4T65-E ('97-UP)

PART NUMBER 84757-01K

Sonnax Part Summary

Relief Valve

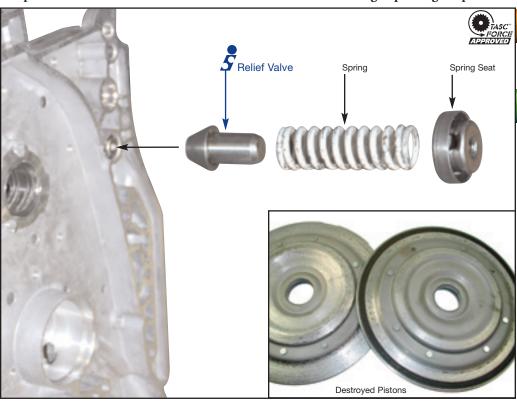
Relief valve doesn't break at low enough pressure.

4T65E transmissions often suffer converter failure during high line pressure conditions such as max adapts or various codes due to excessive apply pressure. The torque converter piston is designed for operating pressures of 135 psi but the OEM apply pressure relief doesn't crack until 175 psi and can allow apply pressure to increase beyond that to over 225 psi. At these high pressures the piston deflects, destroying the piston and lining. The new Sonnax apply relief valve **84757-01K** is calibrated to crack at 135 psi to prevent excess apply valve.

The new Sonnax relief valve will crack and flow at a sufficient rate, which will eliminate TCC piston deflection caused by high pressure.

- Correctly calibrated to release pressure above 135 psi.
- Allows the original chain cover to be reused.
